# WOLF CREEK

NUCLEAR OPERATING CORPORATION

Subject: Docket No. 50-482: Proposed Revision to Technical Specification 3/4.3, Changes to ESFAS Functional Units 6.f, 8.a, and 8.b

ATTACHMENT I  
SAFETY EVALUATION

FIGURE 1

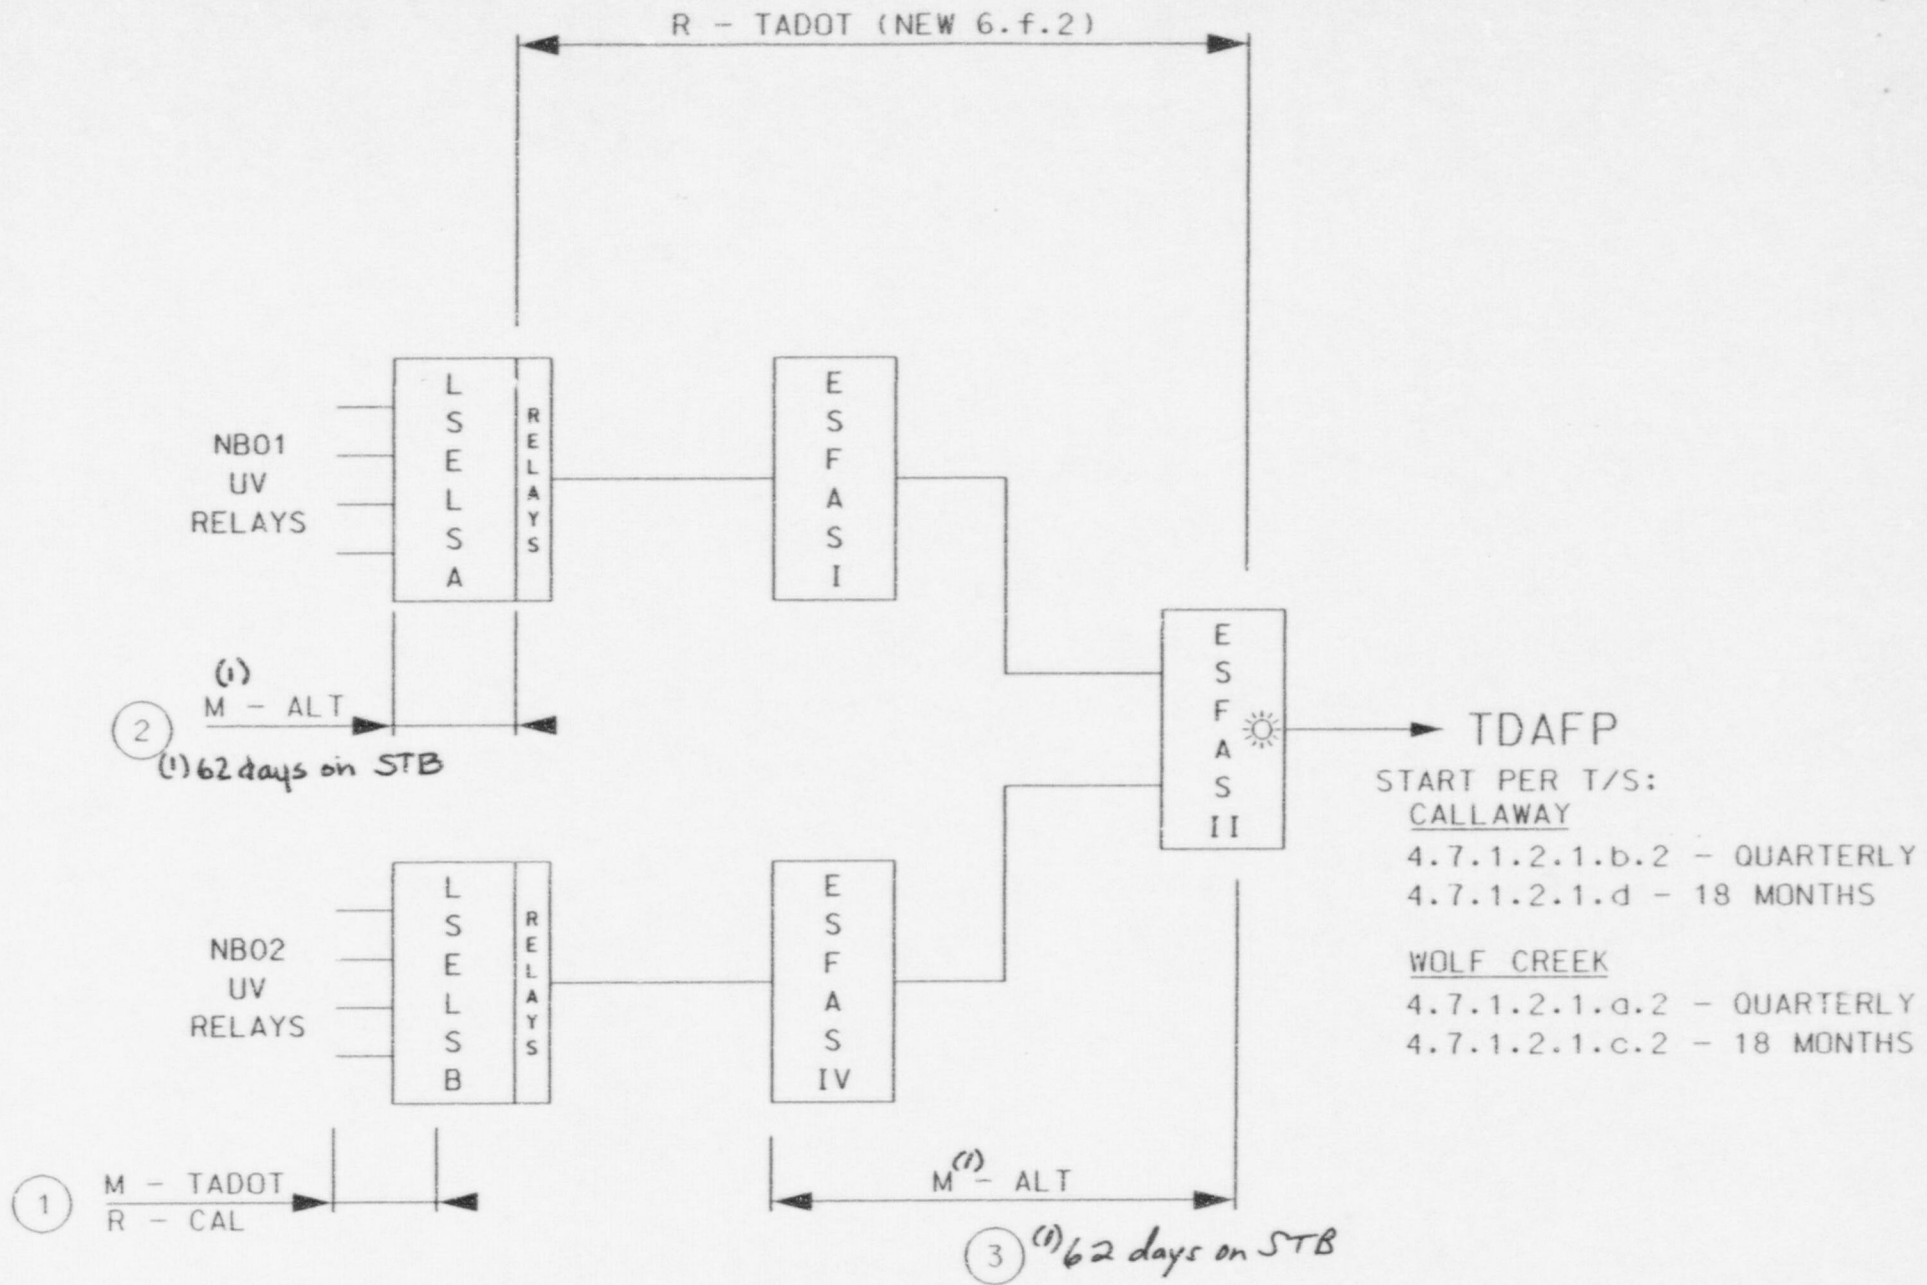
A loss of offsite power (LOP) is indicated by the undervoltage relays detecting a loss of voltage on each ESF bus, as discussed above. Upon satisfying the two-out-of-four loss of voltage logic in the LSELS cabinets, LSELS output relays feed the redundant separation groups 1 and 4 BOP-ESFAS cabinets as shown in Figure 1. The separation groups 1 and 4 BOP-ESFAS cabinets perform several functions, as discussed above, but on a LOP signal these cabinets perform only two functions, i.e., the steam generator blowdown and sample lines are isolated and electrically isolated outputs are provided to the separation group 2 BOP-ESFAS cabinet. The separation group 2 BOP-ESFAS cabinet is only associated with the TDAFW pump and will continue to be considered to be part of that end device, i.e., the TDAFW pump, in the Technical Specifications. On a LOP signal, the turbine steam supply valves (ABHV0005 and ABHV0006) and the turbine trip and throttle valve (FCHV0312) are opened for the start of the TDAFW pump.

- ① TABLE 4.3-2, ITEMS 6.f & 8
- ② TABLE 4.3-2, ITEM 10
- ③ TABLE 4.3-2, ITEM 6.c
